REVISED RESPONSE TO REQUEST FOR ADDITIONAL INFORMATION

APR1400 Design Certification

Docket No. 52-046

RAI No.: 294-8302
SRP Section: 07.05 – Information Systems Important to Safety
Application Section:
Date of RAI Issue: 11/05/2015

Figure 07.05-7-1 HSI Primary and Backup Means

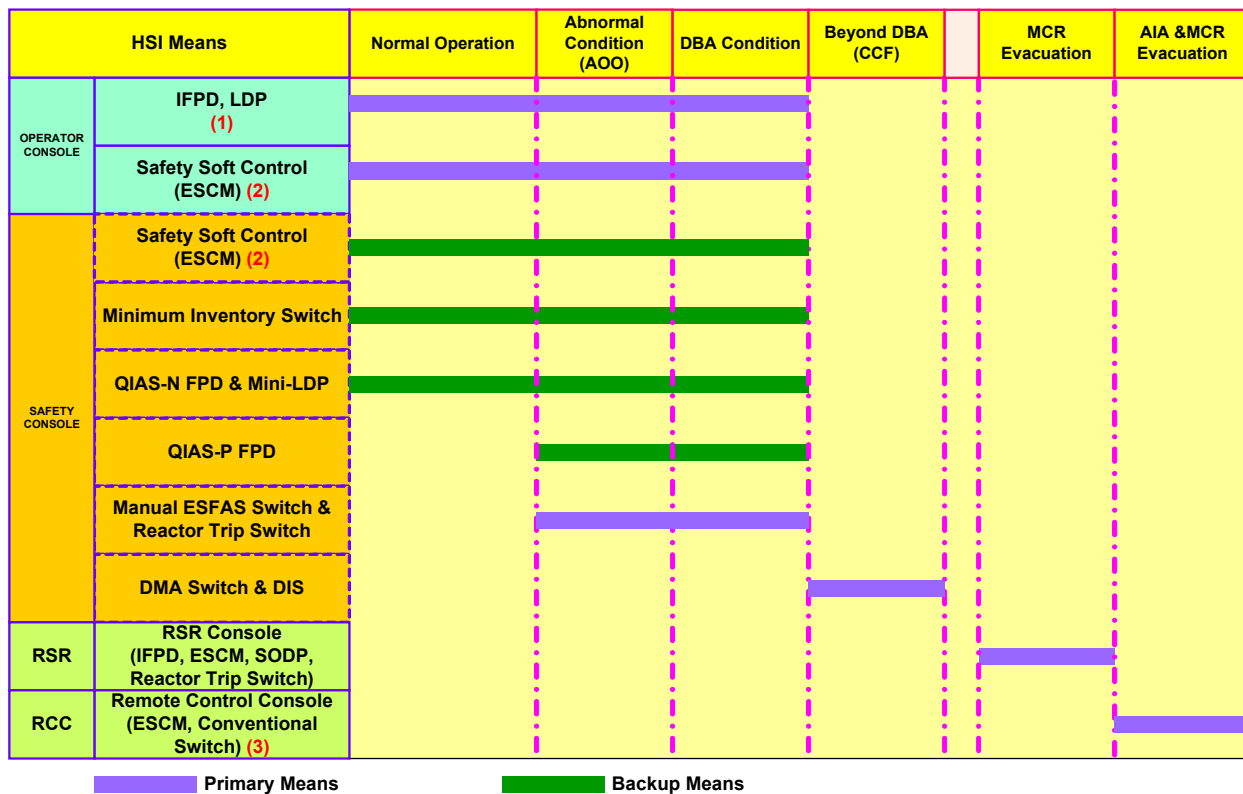
Clarify in the APR1400 FSAR, the instrumentation provided to monitor variables and systems over their anticipated ranges for normal operation, for anticipated operational occurrences, and for accident conditions as required by GDC 13.

10 CFR Part 50, Appendix A, General Design Criteria 13, "Instrumentation and Controls," requires, in part, instrumentation to be provided to monitor variables and systems over their anticipated ranges for normal operation, anticipated operational occurrences, and accident conditions. Is the Information Flat Panel Display (IFPD) in combination with the ESF-CCS Soft Control Module (ESCM) used as the primary controls for safety-related equipment during normal, abnormal, and accident conditions? If so, revise the APR1400 FSAR and associated technical reports to show the IFPD/ESCM are the primary controls for safety-related equipment during normal, abnormal, and accident conditions, or point to the locations in the FSAR indicating they are the primary controls. If IFPD/ESCM are not the primary controls for safety-related equipment, identify the display and control systems that would be the primary controls.

The information flat panel displays (IFPDs) and engineered safety features - component control system (ESF-CCS) soft control modules (ESCMs) on the operator console are used as the primary means of operation as follows:

- The IFPDs are used for non-safety components controlled by the process-component control system (P-CCS) during normal, abnormal, and accident conditions.
- The ESCMs are used for safety components controlled by the ESF-CCS during normal, abnormal, and accident conditions, except during a common-cause failure (CCF) of digital safety instrumentation and control (I&C) systems.

The I&C systems to protect against potential CCF of digital safety I&C systems is described in APR1400 DCD Tier 2, Subsection 7.8.

The safety console provides the operator with credited backup control, alarm, and indication.

The following diagram shows the concept for HSI primary and backup means during normal, abnormal, and accident conditions.

New figure 7.5-3 is added on the page 7.5-24 of DCD Tier 2, Section 7.
